## Walk Toronto Comments on DI19.5 Accessibility- Bloor Street Bike Lane, Shaw Street to Avenue Rd.; and DI19.6 Accessibility at Construction Sites

To: Members of the Toronto Accessibility Advisory Committee

From: Walk Toronto (Steering Committee)

Date: April 18, 2018

**Figure 1** - Vancouver side street accessible parking design allows vehicles to park on side streets close enough to the intersection for people in wheelchairs to make use of corner curb cuts. There are no conflicts with cyclists on bike lanes.

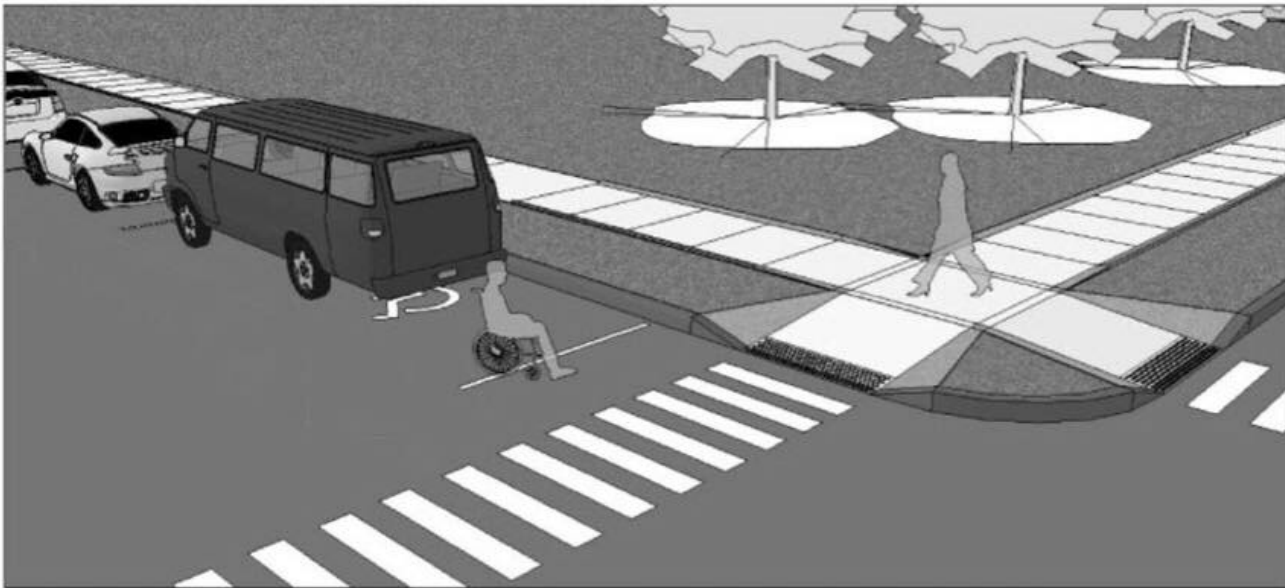
- Instead, accessible parking spaces should be created on every side street near its intersection with Bloor, using a design that is common in Vancouver. (See illustration below).

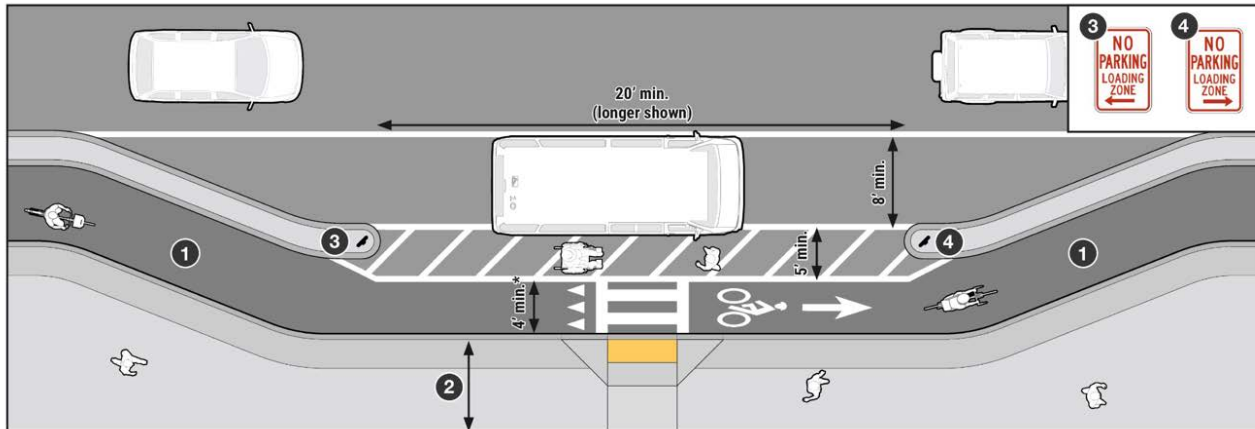
- Accessible mid-block drop-off and pick-up lay-bys should be built in locations where the need is most felt. The floating island design is safest for cyclists, as it does not create holes in the bike lane. The loading zone at Trinity-St. Paul's Church (see p. 3 of the staff presentation) has the right idea, though it lacks the conspicuous pavement markings that we like about the Massachusetts design (see below.) The alternative, a curbside design, is the most convenient for vehicle users, but should be used sparingly.
